**DENDROBIUM AREA 3C
LONGWALLS 22 & 23 SUBSIDENCE MANAGEMENT PLAN
Reasons for Approval**

SMP APPLICATION

- South32 applied for approval of a SMP for Area 3C LWs 22 and 23 on 8 September 2021.
- In addition to the SMP itself, conditions of consent require that the SMP integrates two other more detailed plans, including a Watercourse Impact Monitoring, Management and Contingency Plan (WIMMCP) and a Swamp Impact Monitoring, Management and Contingency Plan (SIMMCP). Each of these plans also contains a Trigger, Action, Response Plan (TARP). Most of the detailed monitoring, management, remediation and contingency measures applicable under the SMP are contained within the WIMMCP and SIMMCP and their associated TARPs. The WIMMCP and SIMMCP contained in the LWs 22 and 23 SMP apply to mining in all of Area 3C.

Figure 1: Proposed Longwalls 22 and 23 in Area 3C

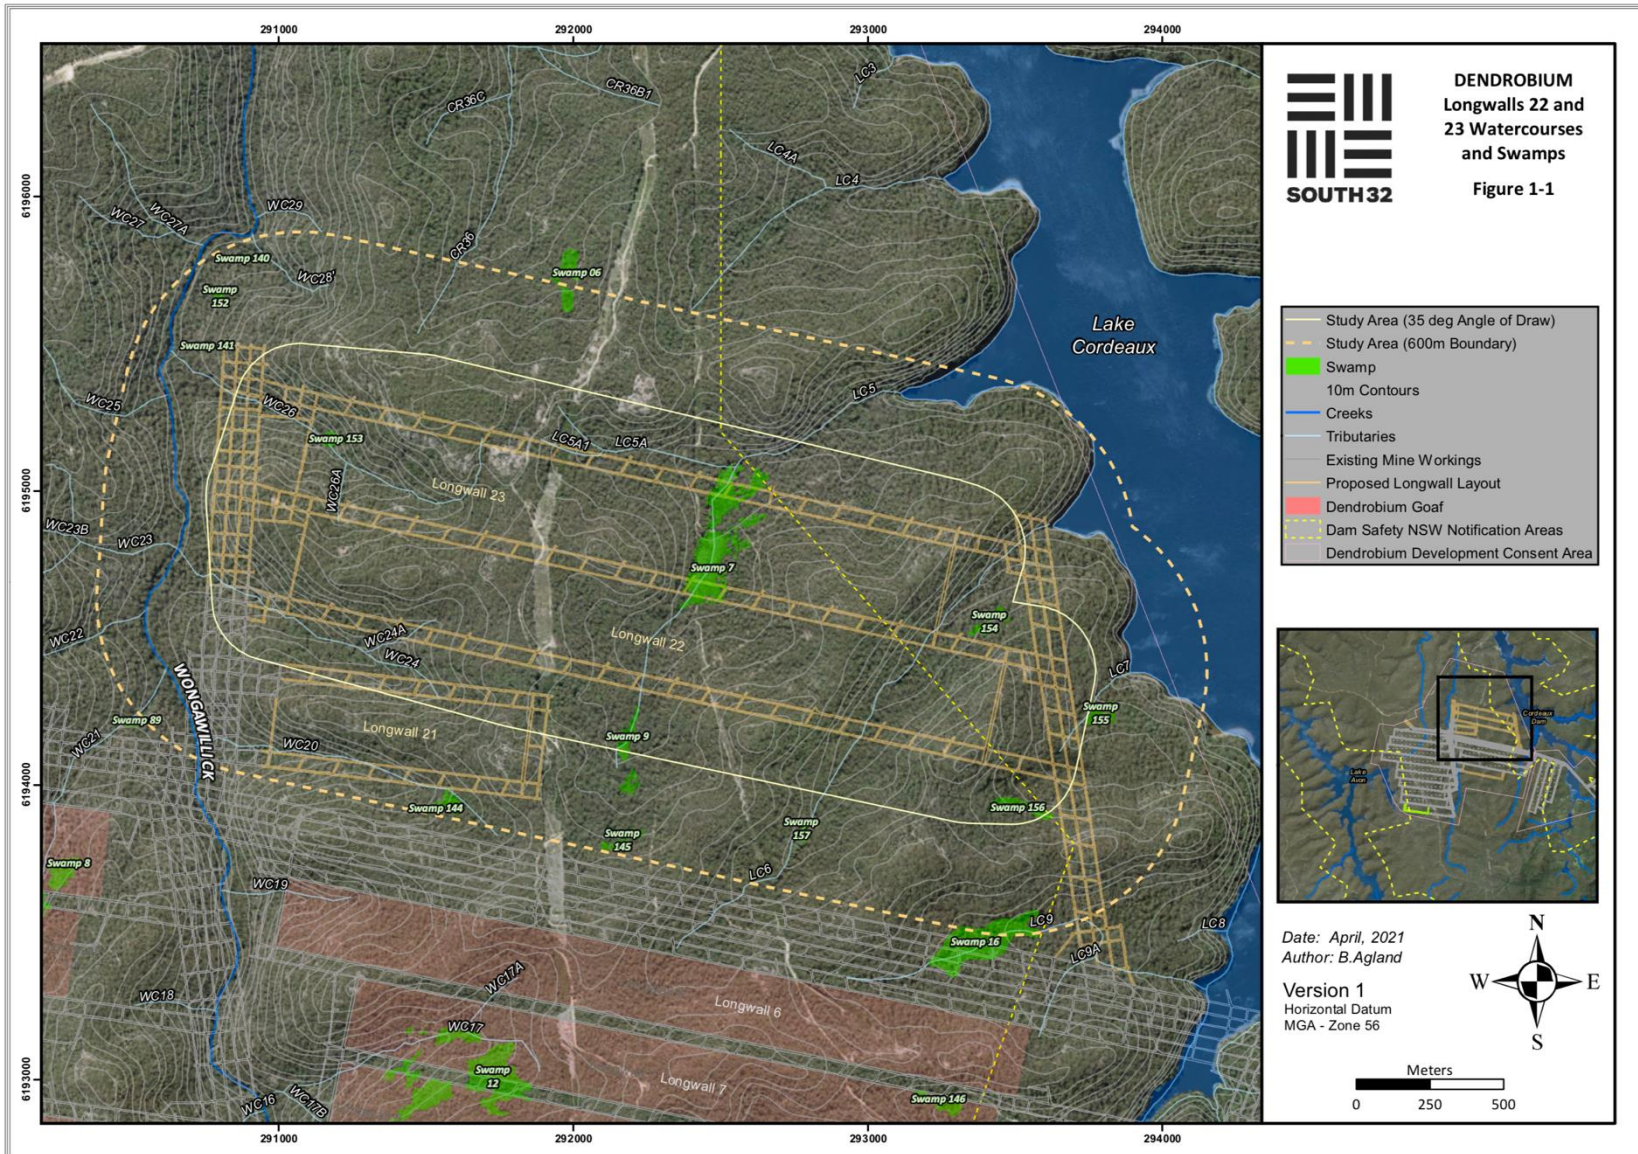
- Both LWs 22 and 23 would be orientated generally east-west between Lake Cordeaux and Wongawilli Creek, north of LW 21 (see **Figure 1**).
- The proposed total void length for LW 22 is 2,561 metres (m) and for LW 23 is 2,283 m. The proposed maximum void width (including first workings) is 305 m for both longwalls, with maximum extraction heights of 3.9 m. The depths of cover to the Wongawilli Seam vary between 290 m along a tributary to Lake Cordeaux above the commencing (i.e.. eastern) end of LW 23, and 390 m along the ridgeline above the LW 23 maingate.

- Two swamps (Swamps 7 and 153) are located directly above the proposed LWs 22 and 23 (see **Figure 1**). An additional four swamps (Swamps 9, 154, 155 and 156) are located wholly or partially within the 35° angle of draw line. The largest and most significant of these swamps is Swamp 7 which is located directly over Longwall 23 and covers an area of 4.9 hectares (ha).
